DEPARTMENT OF TRANSPORTATION STATE OF GEORGIA PROJECT CONCEPT REPORT

Project Number: To Be Assigned
County: Whitfield County
P. I. Number: 0009891
Federal Route Number: N/A
State Route Number: SR 52

PROJECT: I-75 Southbound Off-Ramp @ SR 52 (Whitfield County) PROJECT NO.: 507GA001.006 PROJECT ID: 0009891
 COMMENTS BY: Kittelson & Associates, Inc. RESPONSE BY: Allen Peterfreund DATE: 02/14/2011
 DOCUMENT: Concept Layout CHECKED BY: Brian Mirson SUBMITTAL: Peer Review Page 1 of 6

RECOMMENDED CHANGES TO BASE DESIGN
WHITFIELD COUNTY, GEORGIA
FIGURE 3

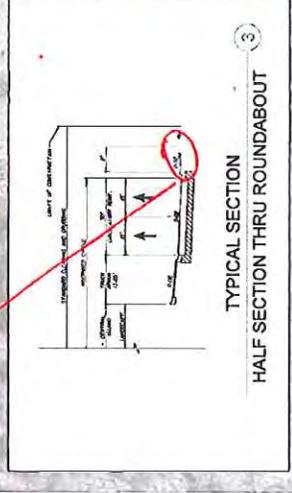
- 7) A minor modification is needed to the channelization within the circulatory roadway in front of the westbound SR 52 entry. The single-lane portion of the circulatory roadway should more clearly direct vehicles only to the outer lane downstream. As currently shown, drivers may

- incorrectly believe that both lanes exit to College Drive, which may cause sudden lane changing.
- 8) Each of the roundabout approaches exhibits some potential for entry path overlap. The alignment of the entries into the circulatory roadway could be improved with the use of a tangent or larger radius curve between the controlling entry curve and the inscribed circle. This would help to better align vehicles at entry to maintain their correct lane as they enter the circulatory roadway.

- 13) For the westbound exit, we recommend that the taper for the left-turn lane should begin after the crosswalk to simplify the exit geometry and lane assignments of the roundabout. This change would also shorten the pedestrian crossing distance. The reduced storage length should still adequately accommodate queues for what is a low-volume movement.

① In general, set sidewalk back from curb if possible

Appendix 1
ACP Base Design

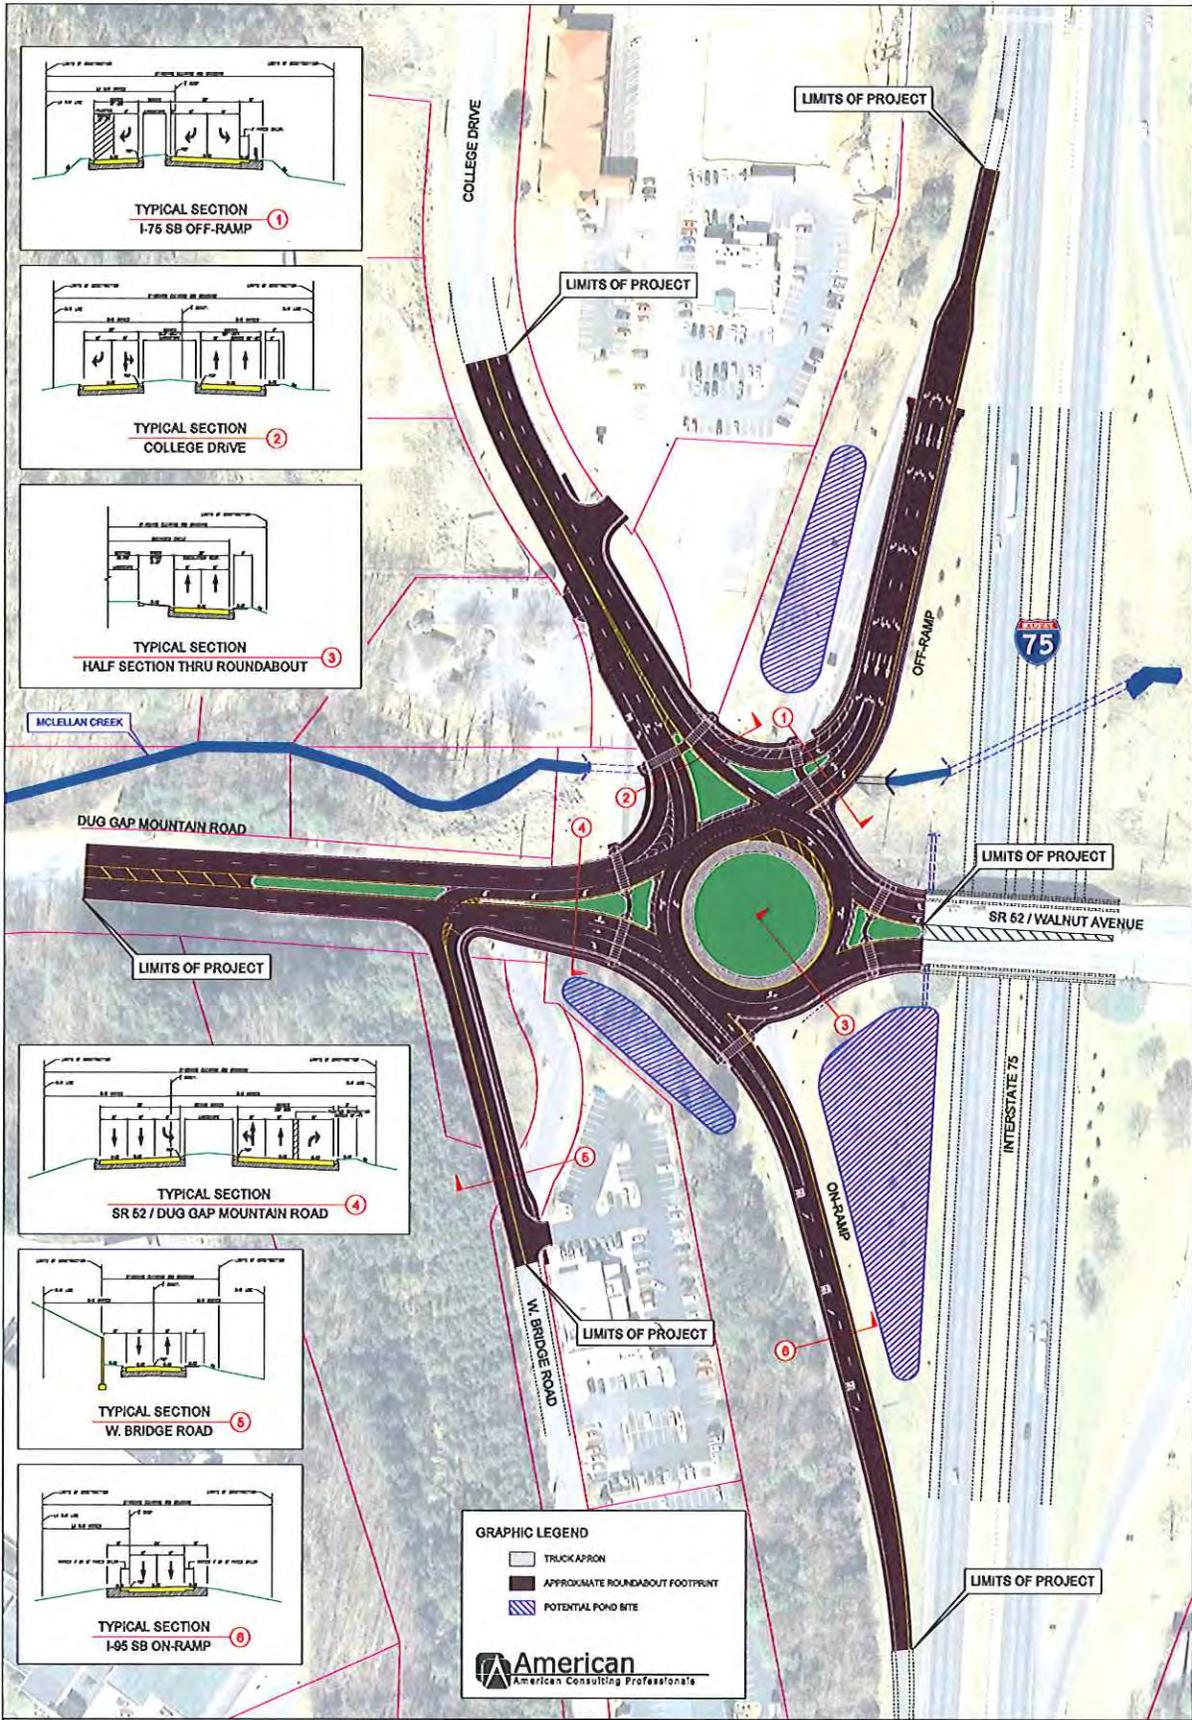
| NO. | PAGE | COMMENT | RESPONSE |
|-----|------|---|---|
| 1 | 2 | Consider removing the right-turn bypass from SR 52 eastbound to the I-75 on-ramp. This is a very low-volume movement (highest projected hourly volume is 44 vehicles) and can adequately be served by the approach without a bypass lane. The bypass lane as currently designed presents a number of challenges. | This lane was included to provide a dedicated lane for SR 52 eastbound traffic and SR 52 westbound traffic, similar to the existing configuration. Additionally, the bypass lane pulled the SR 52 eastbound to I-75 southbound traffic out of the roundabout. Based on the new traffic counts and the revised design year projections (changed from 2019 to 2032), the highest projected hourly volume is 103 vehicles. Our analysis indicates that the proposed roundabout has adequate capacity to handle the additional traffic from SR 52 eastbound to the I-75 on-ramp. Based on the peer review recommendation and realizing the concerns related to entry speeds, pedestrian safety and functionality, the by-pass lane at this location will be eliminated. |
| 2 | 2 | Consider removing the southbound right turn bypass/lane from College Drive to SR 52 westbound. The bypass/lane is not needed for capacity and is not a continuation of a basic lane on College Drive. Its inclusion creates additional conflict points, a wider pedestrian crossing, and complex signing and striping needs. | This lane was included to provide a dedicated lane for College Drive southbound traffic to SR 52 westbound, similar to the existing configuration. Additionally, the bypass lane pulled the SR 52 eastbound to I-75 southbound traffic out of the roundabout. Based on the new traffic counts and the revised design year projections (changed from 2019 to 2032), the highest projected hourly volume is 47 vehicles. Our analysis indicates that the proposed roundabout has adequate capacity to handle the additional traffic from College Drive southbound traffic to SR 52 westbound. Based on the peer review recommendation and realizing the concerns related to conflict points, pedestrian safety and signing, the by-pass lane at this location will be eliminated. |
| 3 | 3 | KAI performed a check of fastest path speeds for base design; these checks are shown in Figures 1 and 2. Both the southbound and eastbound entries are estimated to allow entering vehicle speeds in excess of 30 mph when vehicles ignore lane markings on the roundabout approach. Speed control at entry is one of the key design objectives to provide for safe roundabout operations. Refinements to the entry geometry should be considered to further limit potential fastest path speeds. | Removing the slip ramps for SR 52 eastbound traffic to the I-75 southbound on-ramps and for College Drive southbound traffic to SR 52 westbound reduces the entering speeds for these movements. Further refinements to the roundabout approaches provide entry speeds of 25 mph for SR 52 eastbound traffic and 25 mph for College Drive southbound traffic. Entry speeds are based on vehicles ignoring lane markings on the roundabout approach. |
